34901A-07

# Modification Recommended Service Note

## 34901A Armature Multiplexer Module for 34970A/72A, 20-Channel

The Problem – Hard or too tight to insert the module into 34970A/34972A

#### Situation:

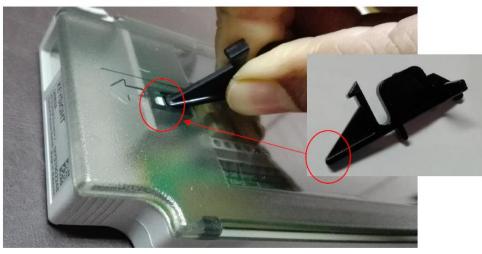
34901A module within the serial number may experience hard or too tight to insert into 34970A/34972A main frame. The top cover width and thickness dimension were out of specifications.

The module that has difficulty to insert into 34970A/34972A can be enhanced by replacing a new top cover. Users can contact Keysight Service Center to request for the enhance top cover and replace by referring to the following procedure as below:
